DESIGN ADVISORY BOARD Tuesday March 27th, 2018 at 3:00 PM Conference Room 12, City Hall, Burlington, VT Agenda

MEMORANDUM

To: The Design Advisory Board
From: Mary O'Neil, AICP, Principal Planner
RE: ZP18-0757CA; 131 Lakeview Terrace
Date: March 27, 2018

Request: Addition and renovation to historic single family home.

ELEVATIONS		
No.	Description	Date
		A.1
Project number A2017046		
Date 03.07.18		
		Scale 1/8" = 1'-0"

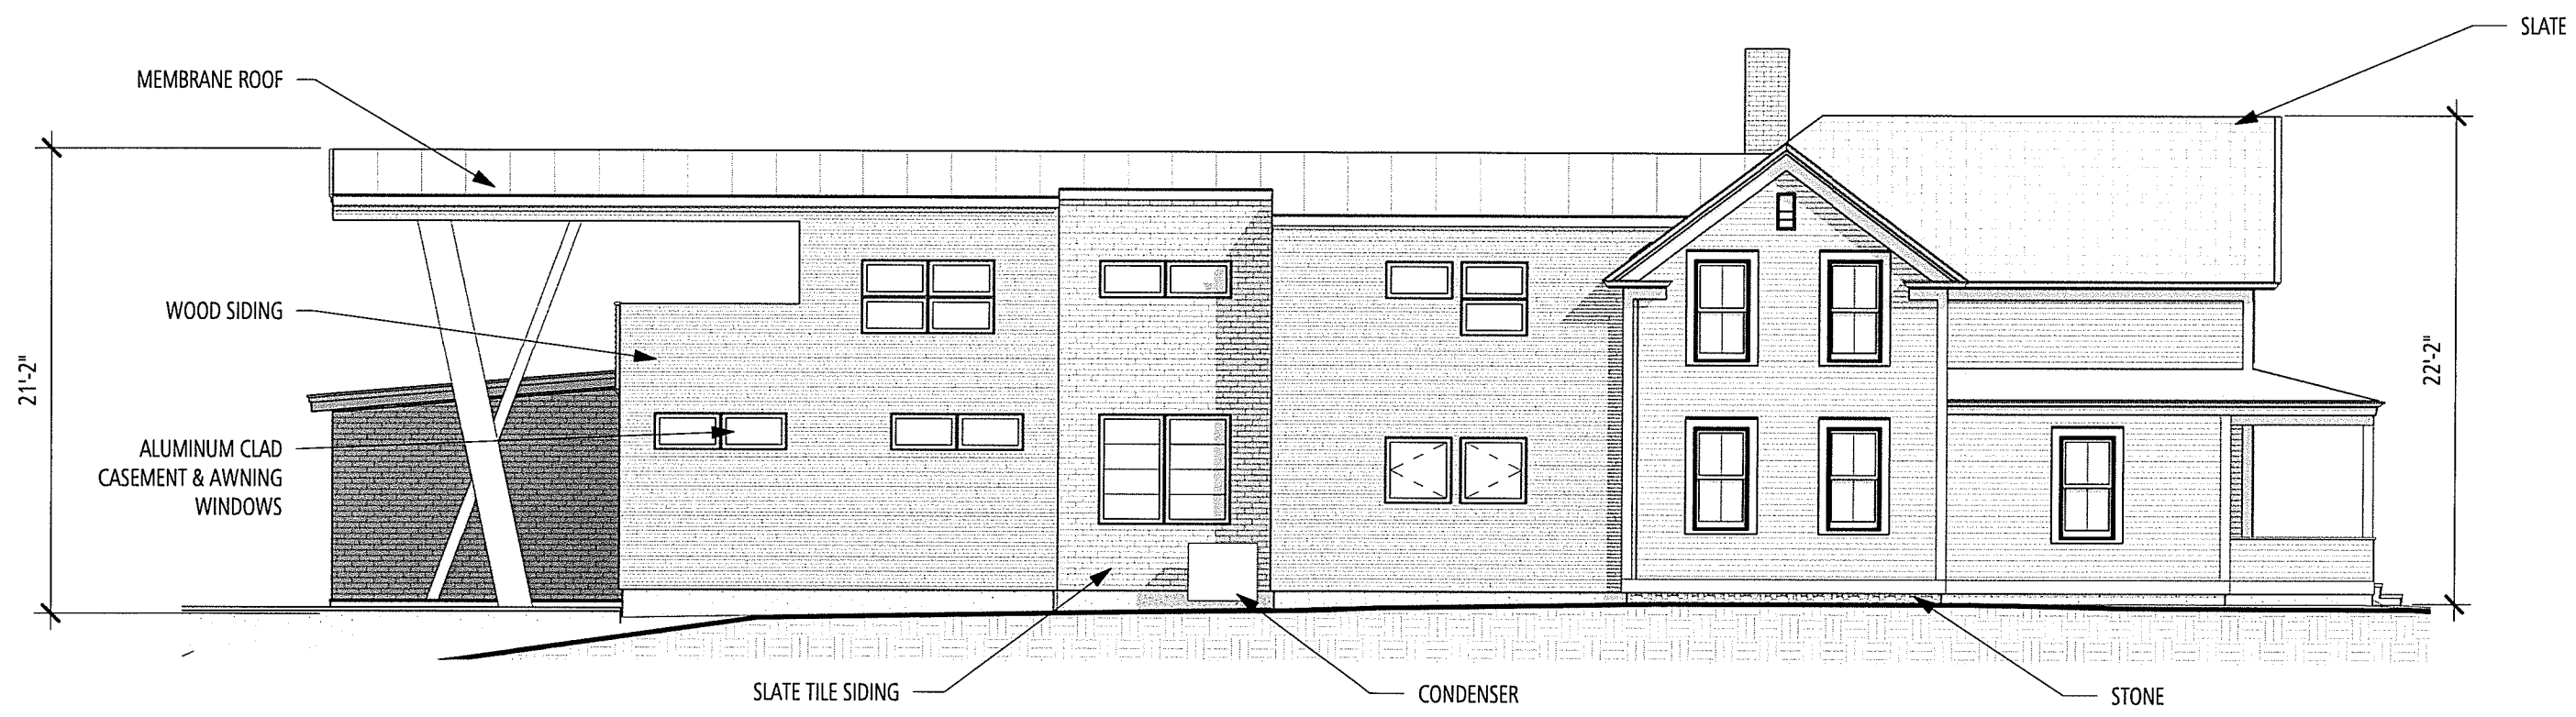
A condensing unit is illustrated on plan A.1, but finds itself within a required side yard setback on PZ2. It will need to be relocated outside that setback. Its new location shall be identified on revised plans.

1. The condensing unit will need to be relocated outside required setbacks. Screening may be required to minimize visibility. The new location shall be identified on revised site plans/elevation as appropriate.

A-200

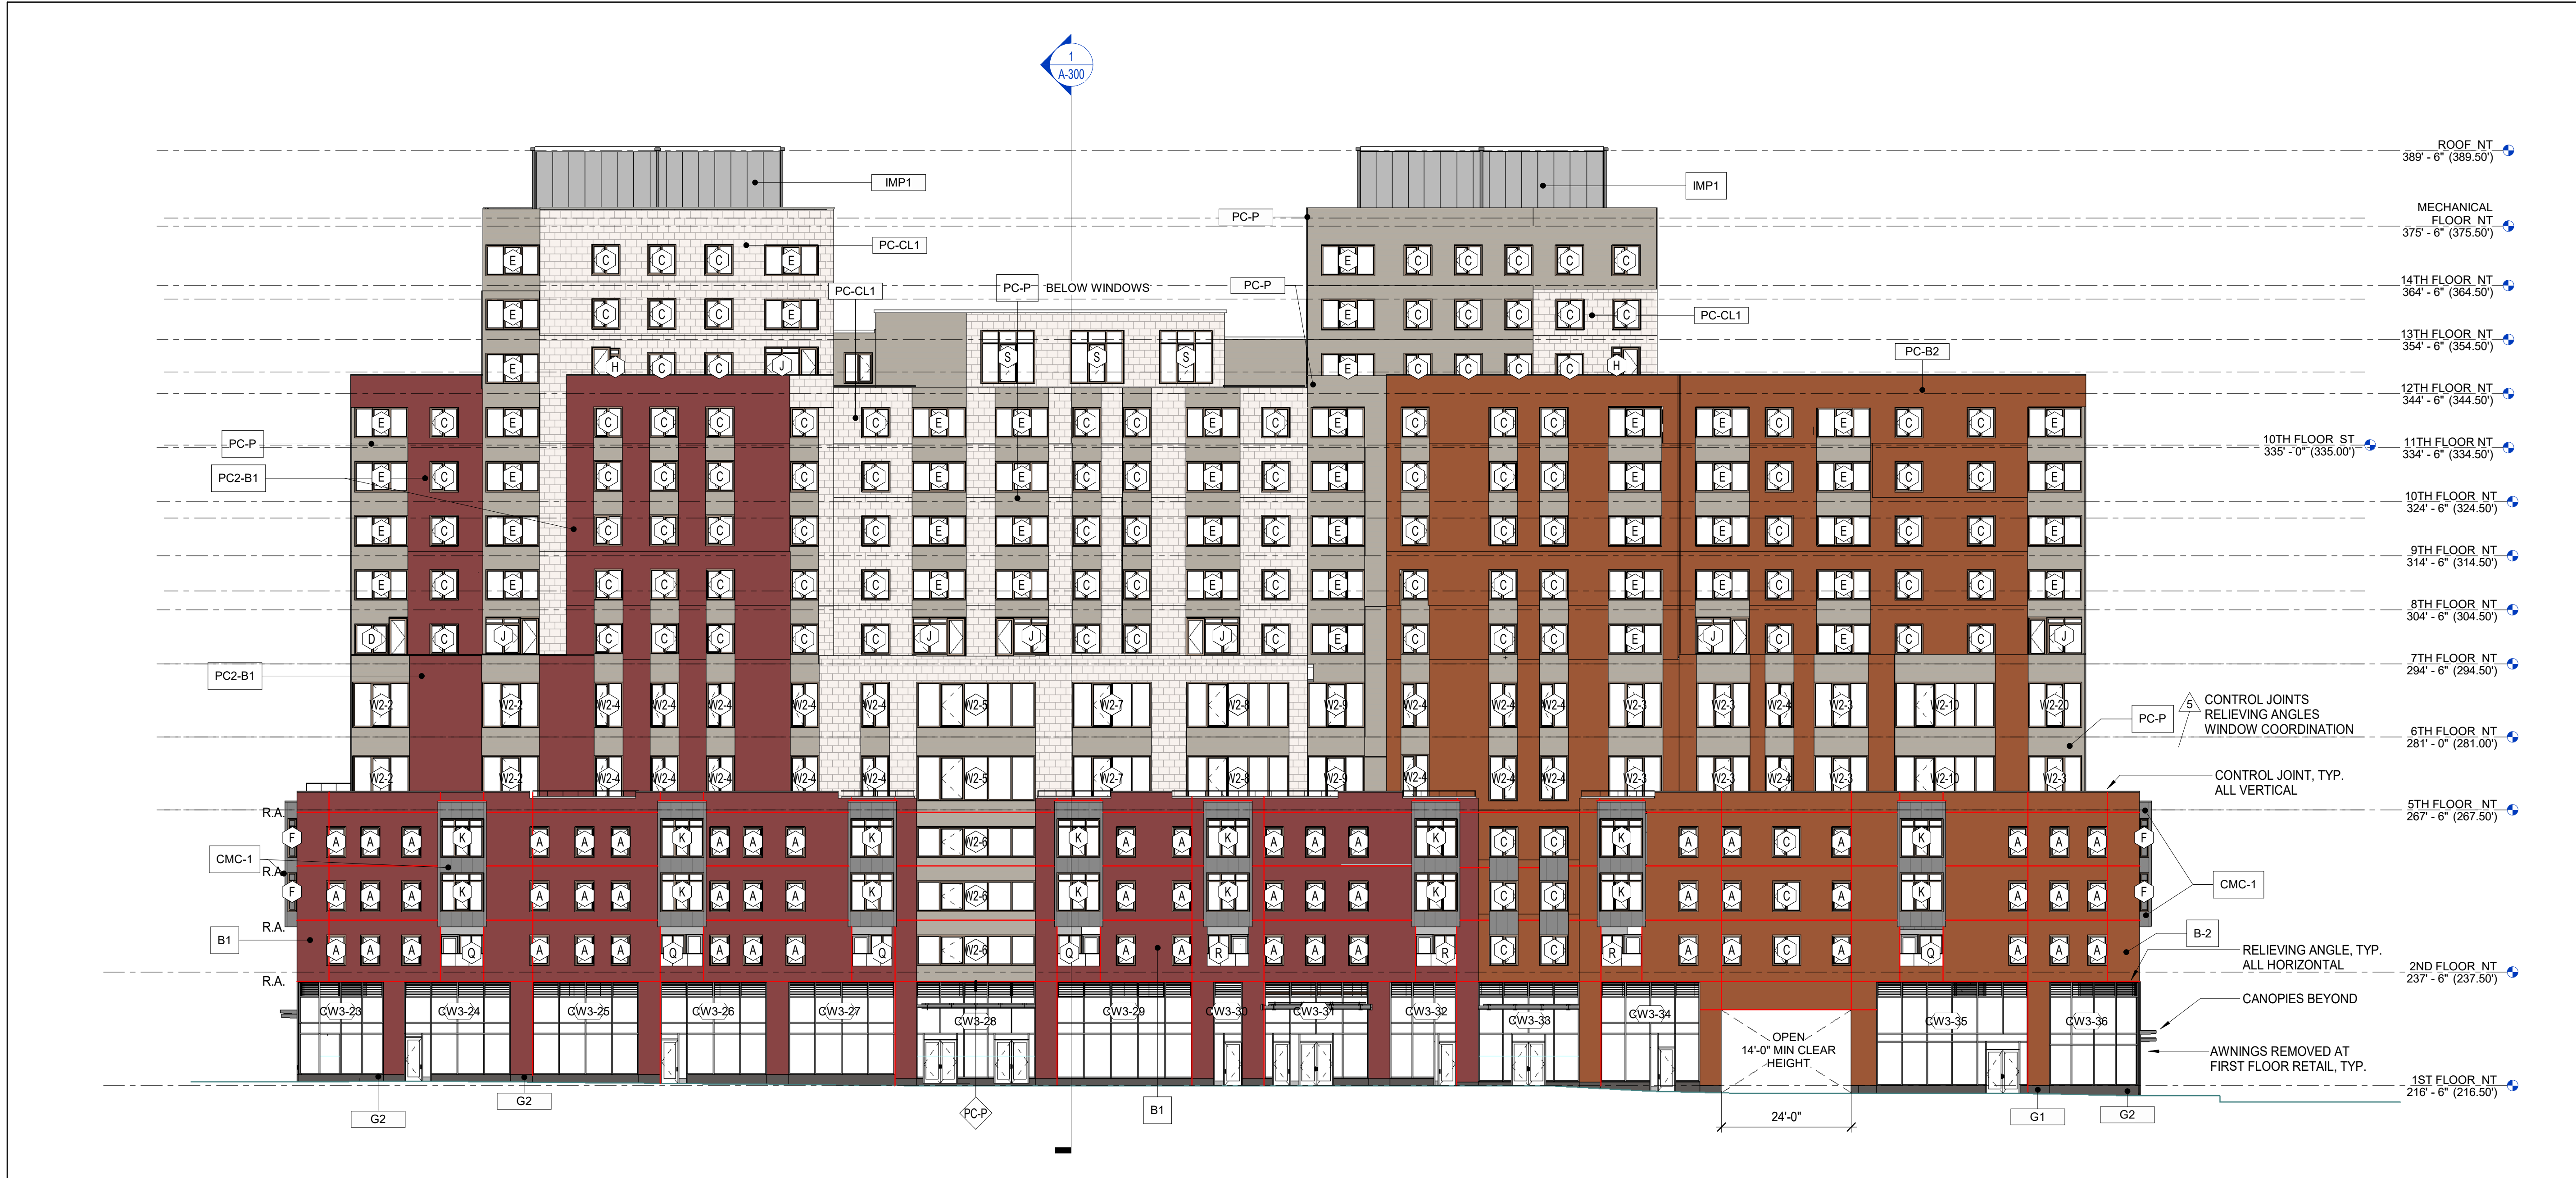
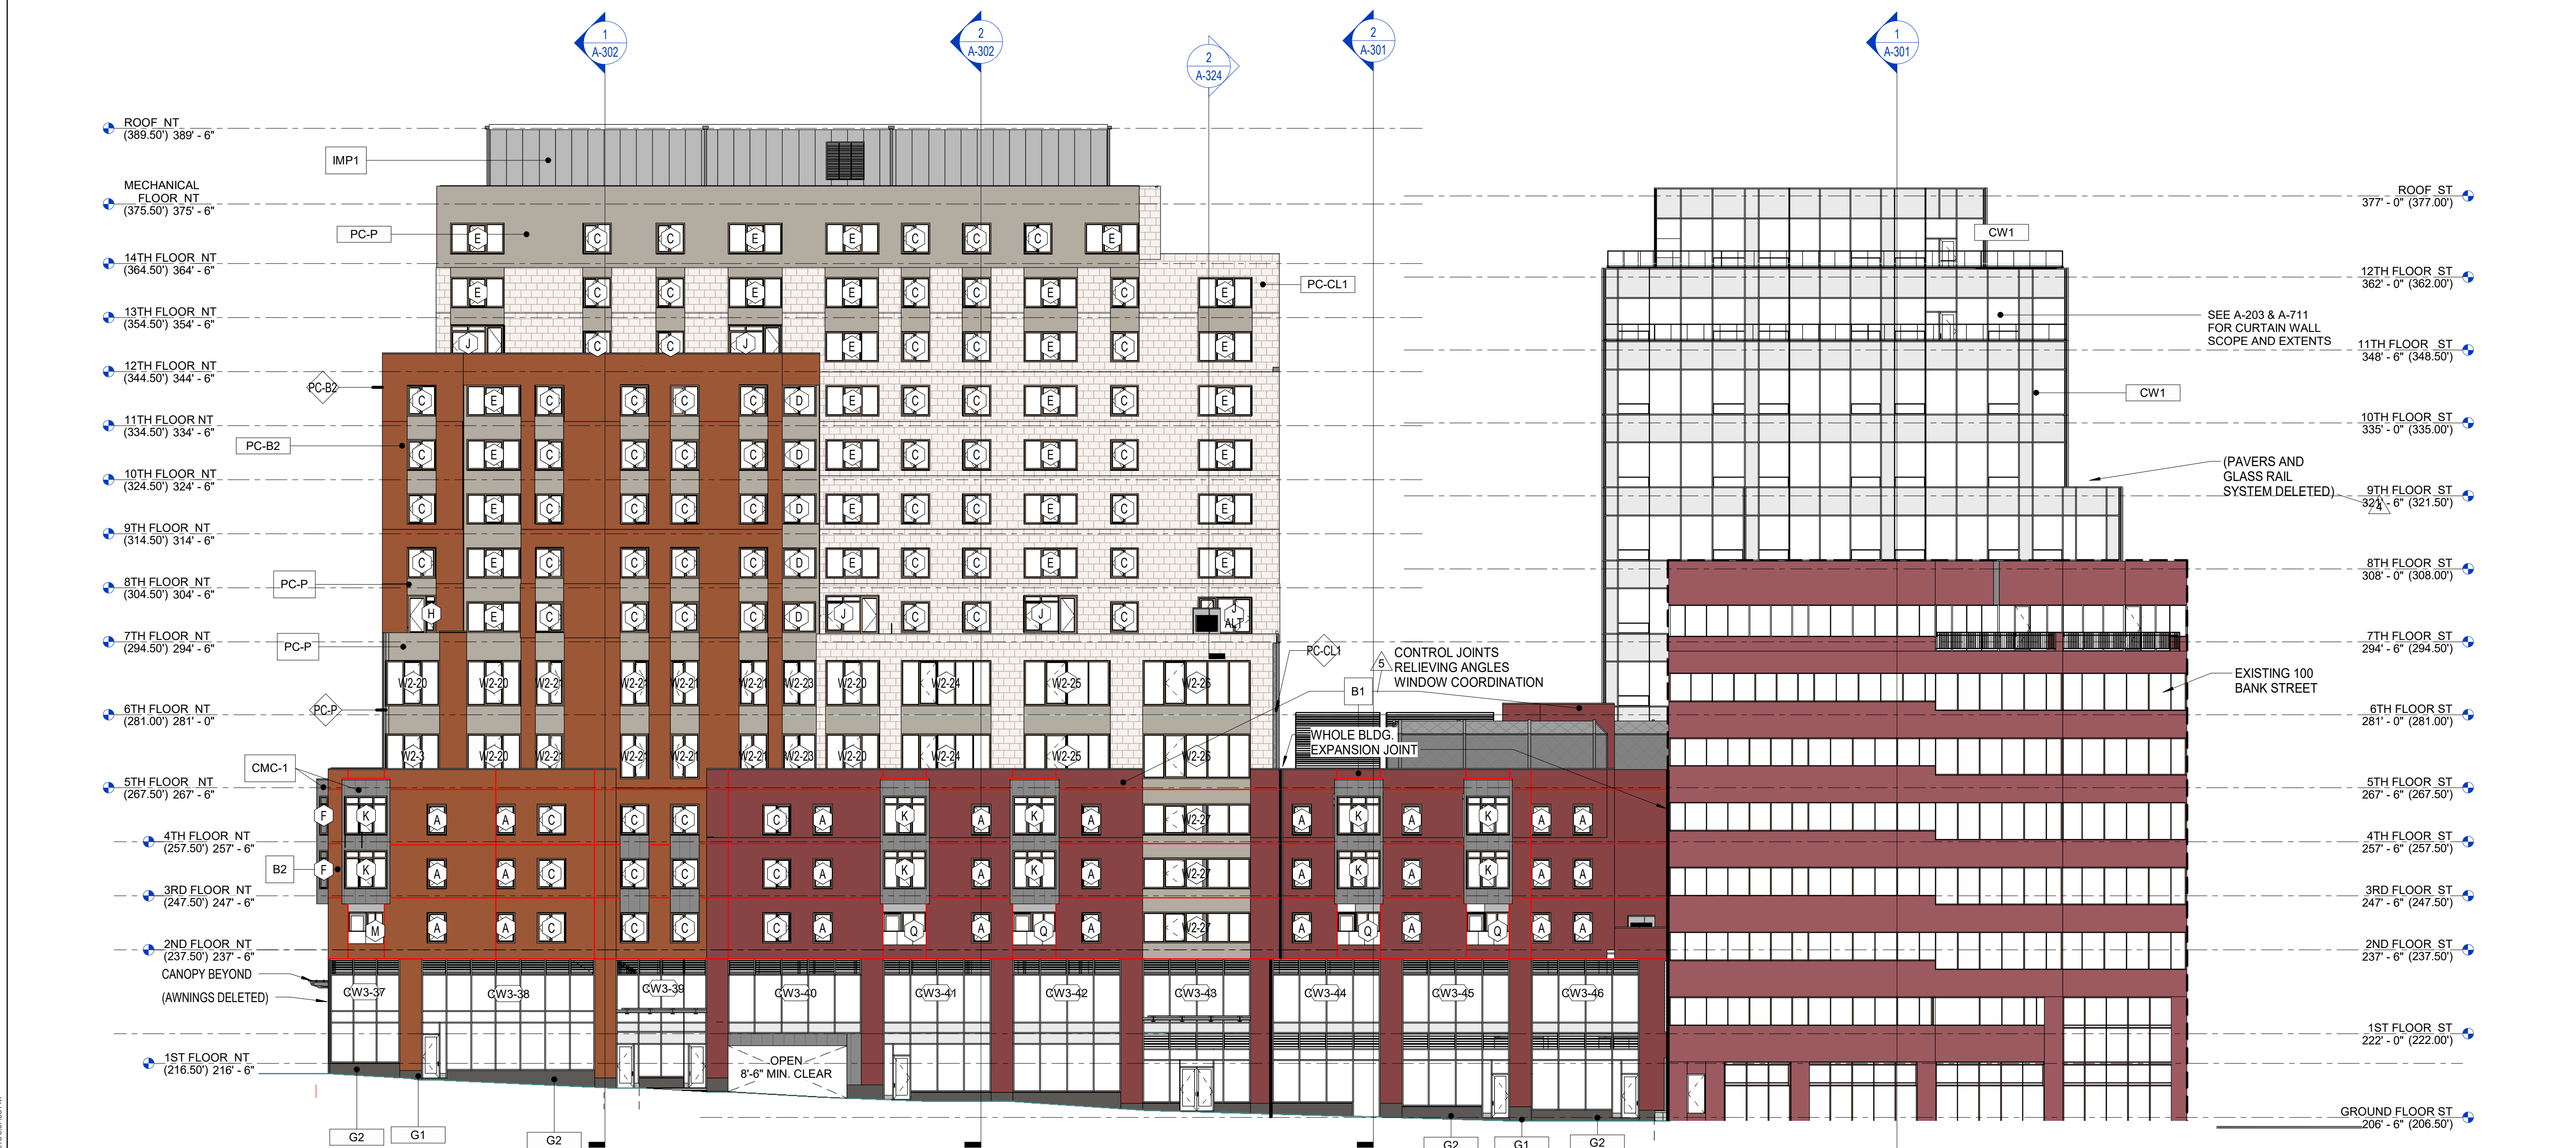
The pool/deck feature on the 7th floor will not be visible from any of the streetfront elevations (see Plans A200-A201.) The fitness center at the 12th floor will be apparent only from the north (Cherry Street) façade as a small building volume that is largely unapparent from street view (see lower illustration at A-202, sight lines noted.)
